**CORRIGENDUM**

**Addendum No. 01 dated 22.07.2020**

**TENDER NO. SJI4441P21**

Drawing No.:  
OIL/RF/PDN/37.37 KL tank/02

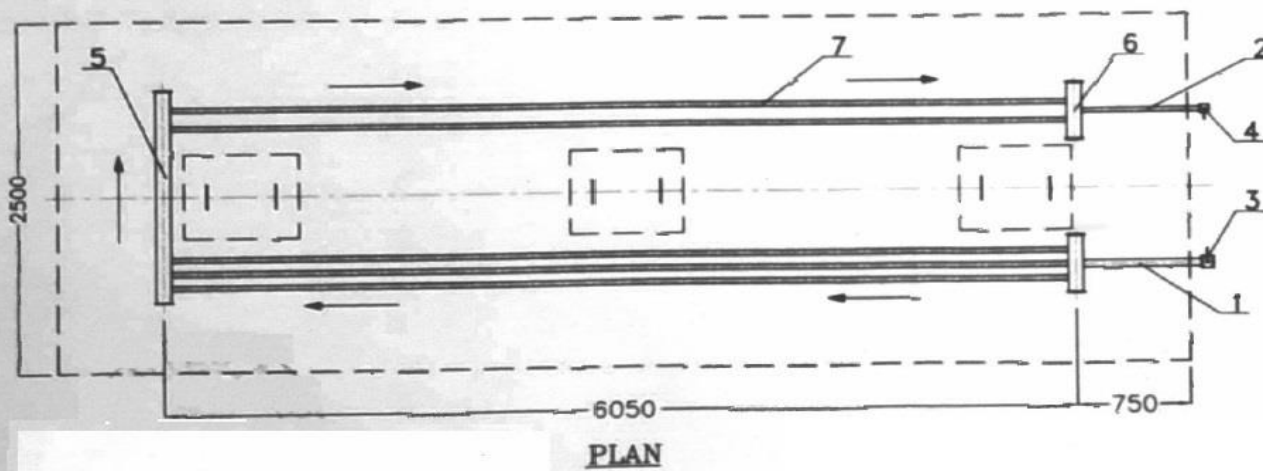
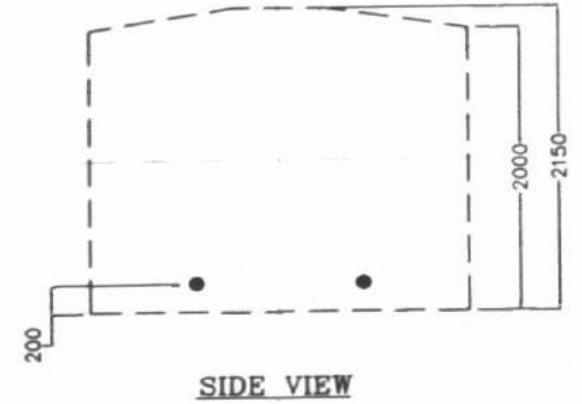
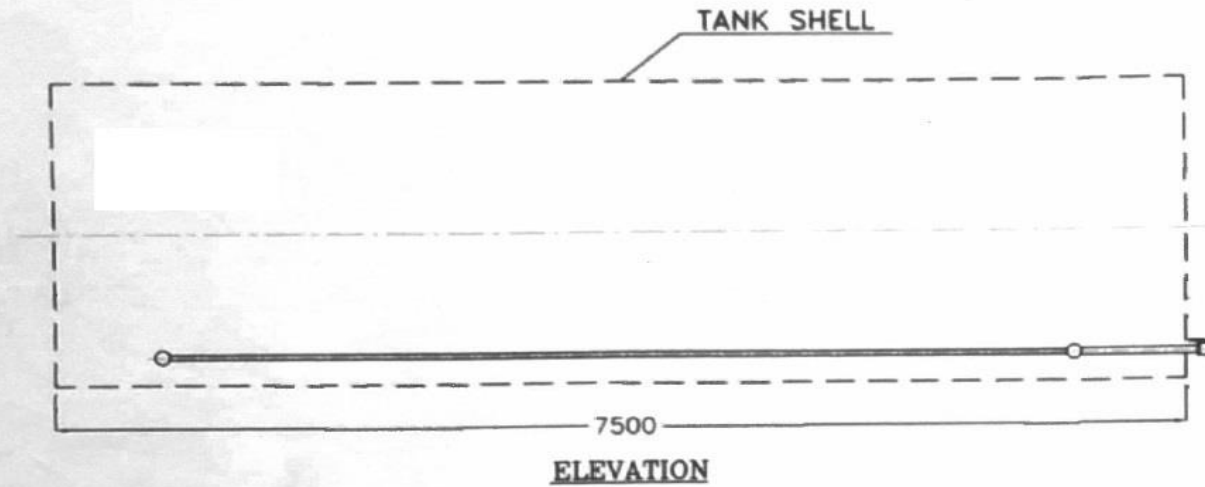
- 1.0 This addendum is issued to replace the Drawing No. OIL/2984/C with following two drawings. Bidders are requested to consider the following two drawings while submitting their bids.
- i) Drawing No.: OIL/RF/PDN/37.37 KL tank/01 (Copy enclosed)  
ii) Drawing No.: OIL/RF/PDN/37.37 KL tank/02 (Copy enclosed)
- 2.0 Accordingly, the last Note under the material description shall be amended as under in lieu of existing.

This drawing is for reference purpose only. The bidder has to design the tanks (including steam heating coils) as per NIT and the same needs to be get approved from Oil India Limited before fabrication of the tanks
